**CONFERENCE CALL AGENDA
BEACON SOLAR ENERGY PROJECT
(08-AFC-02)
WEDNESDAY, MAY 21, 2008 (10:00 a.m. to 12:00 p.m.)**

**CONFERENCE CALL MEETING NOTES
BEACON SOLAR ENERGY PROJECT
(08-AFC-02)**

Resolve issues raised by California Department of Fish and Game (CDFG) regarding additional information needs for completing Incidental Take Permit (ITP) application for desert tortoise (DT) and Mohave ground squirrel (MGS).

Figure 1
Project Site Boundary and
Survey Area

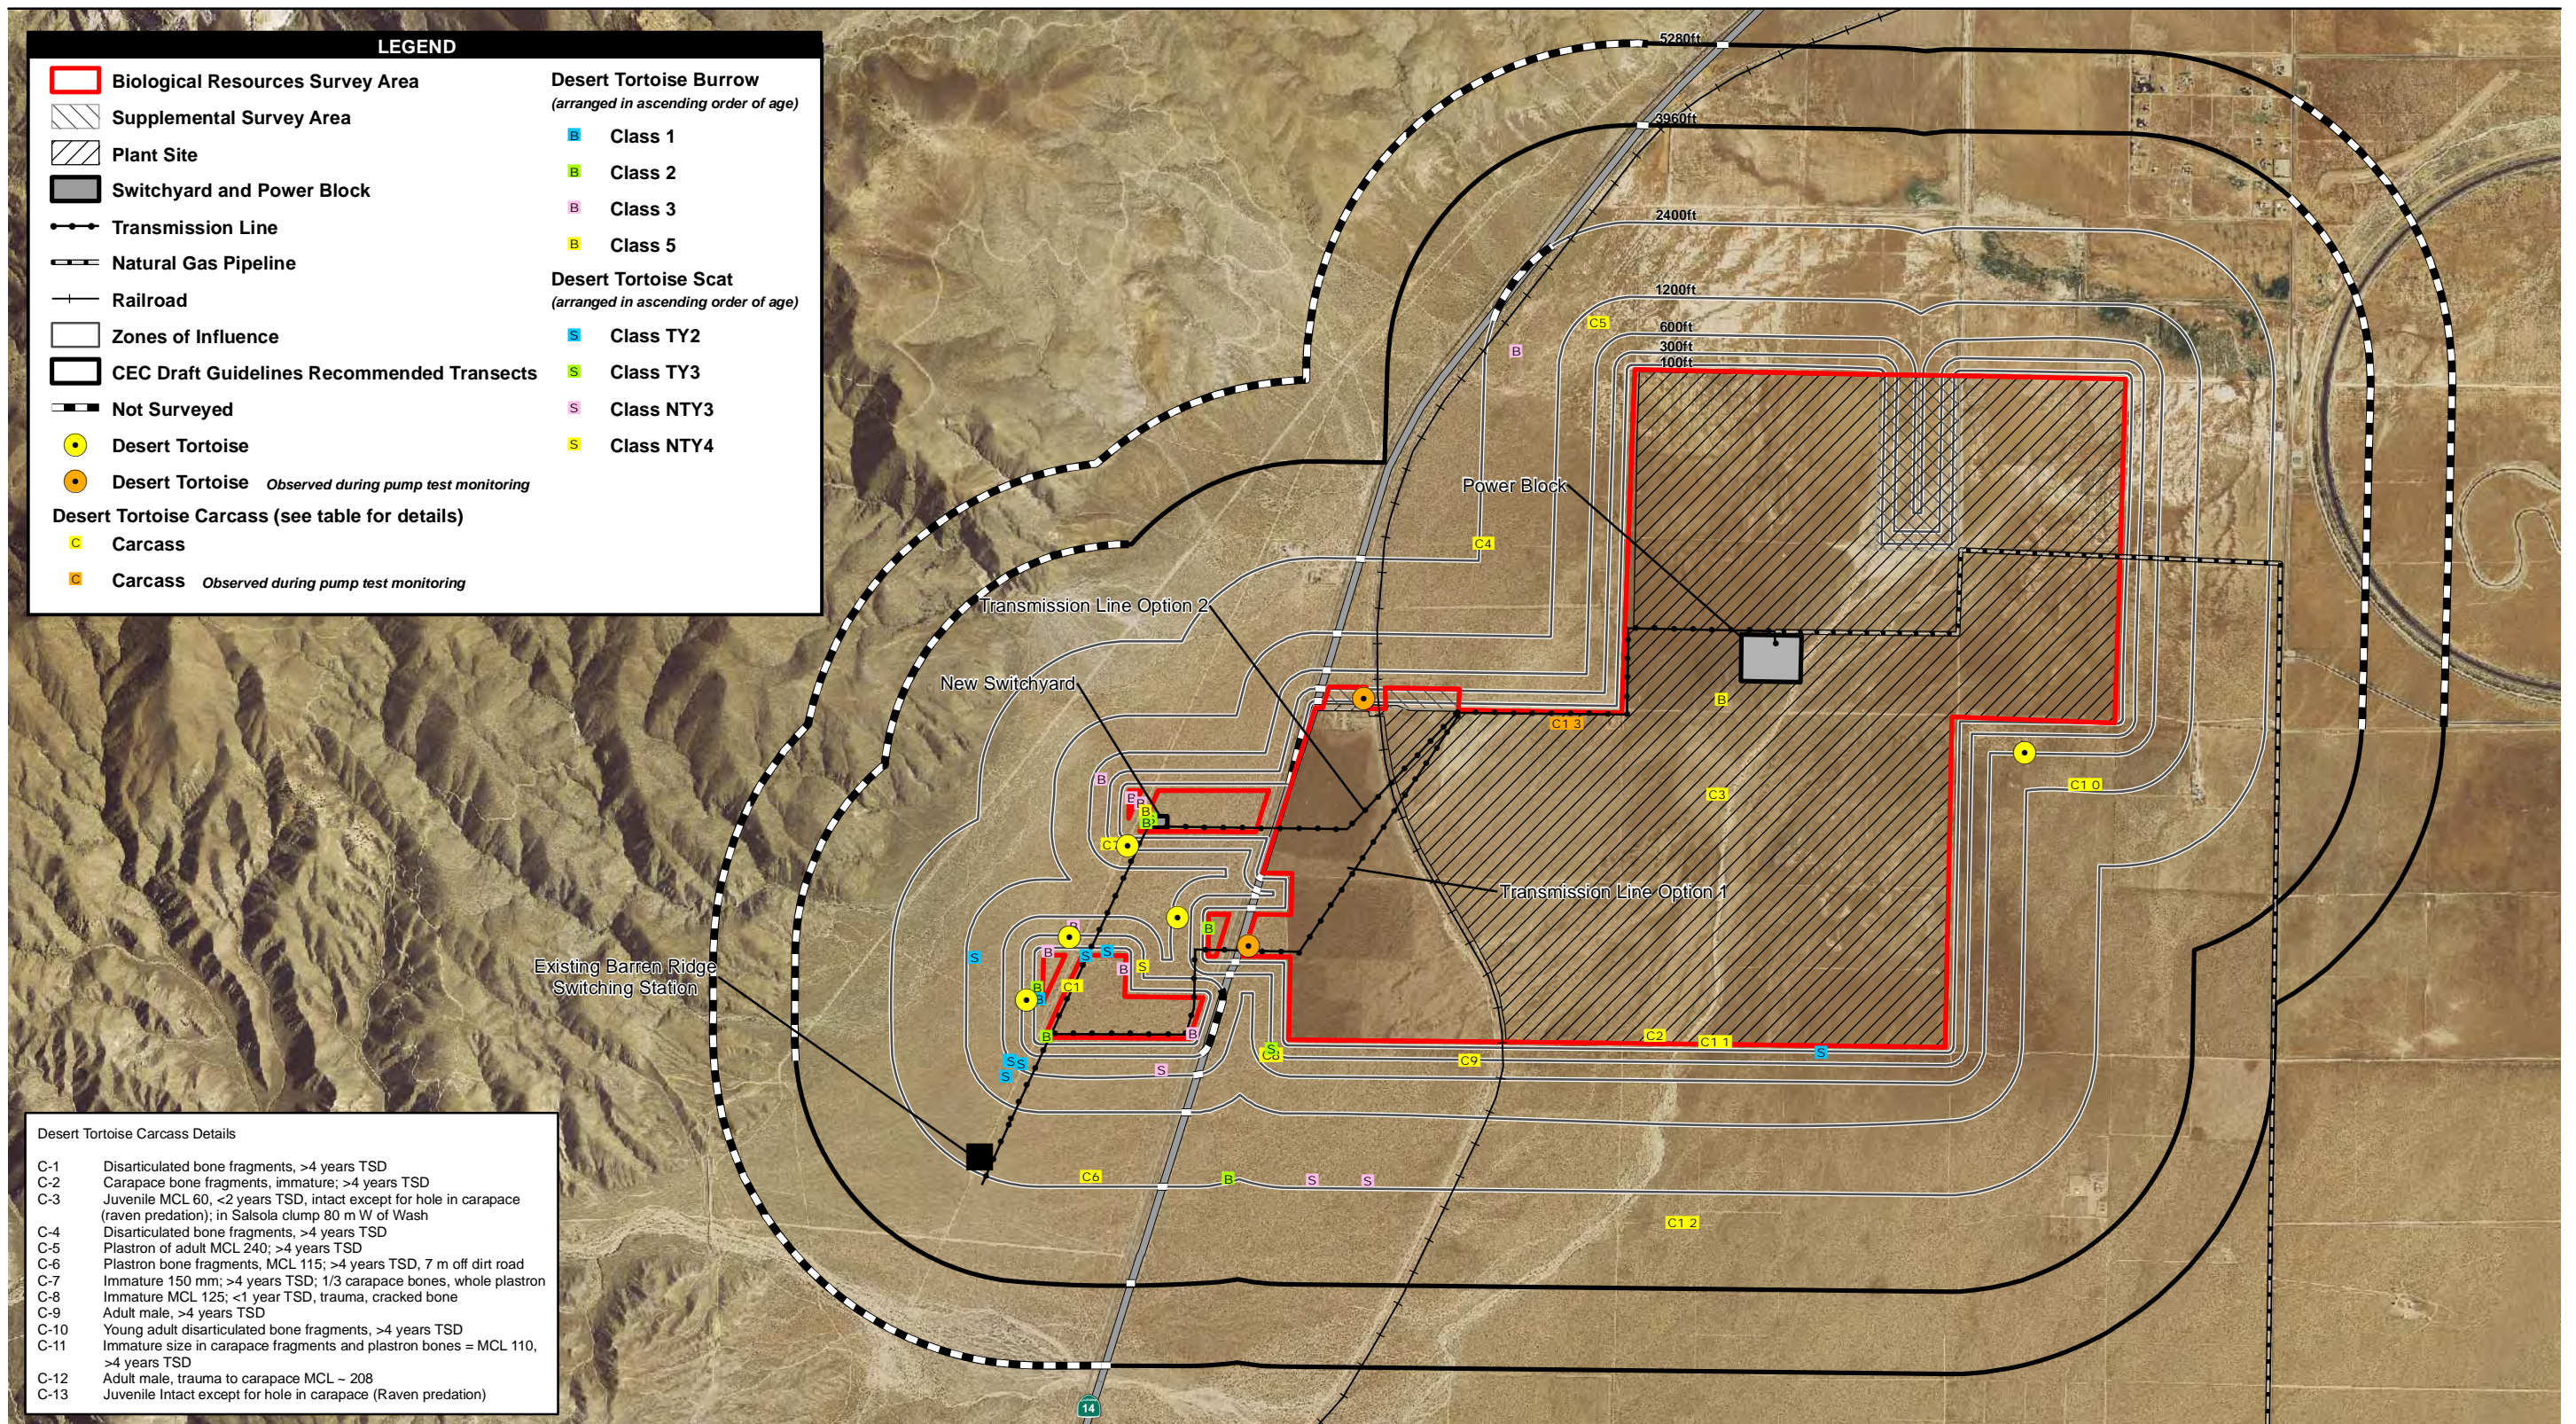
Kenny referred to Figure 1 of the pdf handout showing the plant site boundary, and discussed the linear facilities (gas pipeline and T-lines). No staging or laydown areas are shown within the plant site boundary because the entire site will be graded and it is assumed everything within the boundary will be impacted. For the gas pipeline, all disturbances will be in the disturbed shoulder or on the roadway.

Julie asked if they had cleared this construction with Kern County, and what the depth of the gas line trench would be. Kenny said all disturbances will be in the shoulder or road and that the county is aware of this. The pipeline is small, 8" in diameter, and construction will be done quickly. T-line access will be primarily on existing Los Angeles Department of Water and Power (LADWP) dirt roads, with a few short access/stubs. All new disturbances were included in the impact calculations. Kenny will check to make sure all that information was clearly stated in the ITP application, and if not he will add it.

Figure 5
Desert Tortoise and Sign

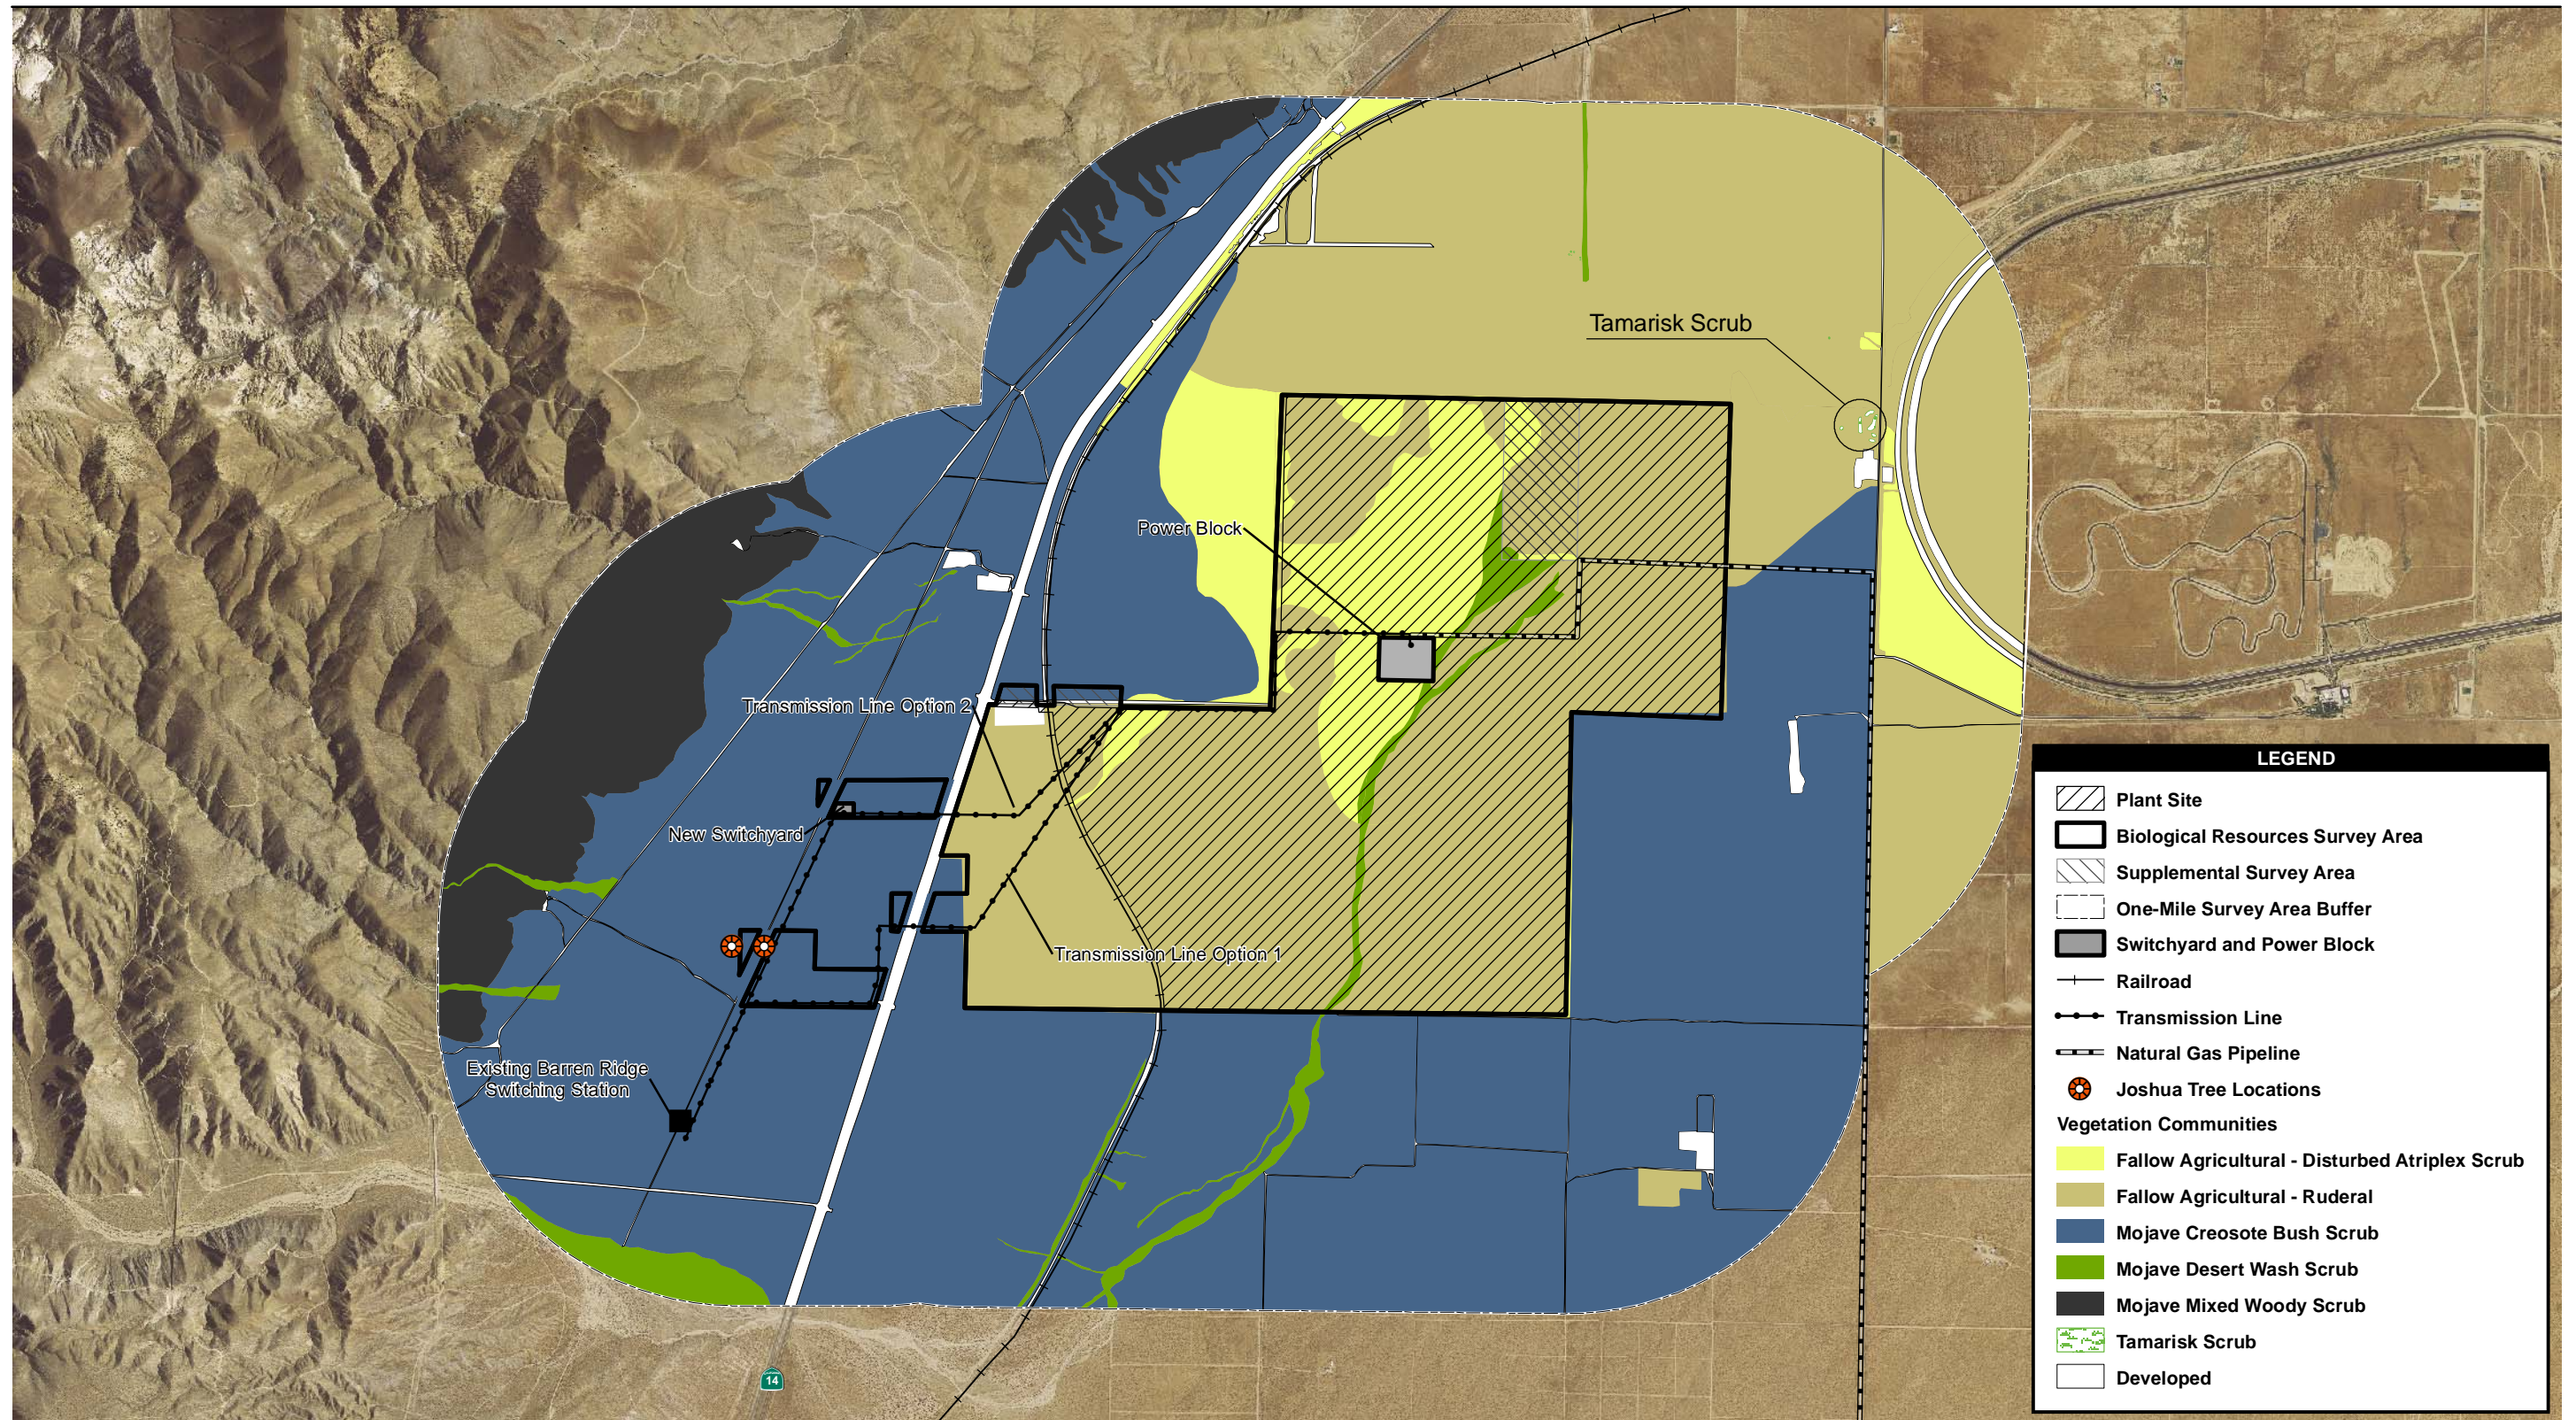
Kenny respectfully disagreed with the statement in the CDFG response letter that because some DT sign was detected, there might be DT dispersal in the area. Examining Figure 5, Kenny noted that no scat was found on the plant site and that the

only sign of DT within the plant site boundary was depredated juveniles C-13 and C-3. C-2 and C-11 were old bone fragments close to the wash. A Class 5 burrow was detected in the middle. In the surveys done this year and in 2007, they have not seen any sign that DT are using or have recently used the site. While there was quite a bit of activity west of SR 14, the highway acts as a barrier. If DT were dispersing across the plant site, biologists would have seen sign during the protocol surveys conducted in 2007 and 2008 but did not.
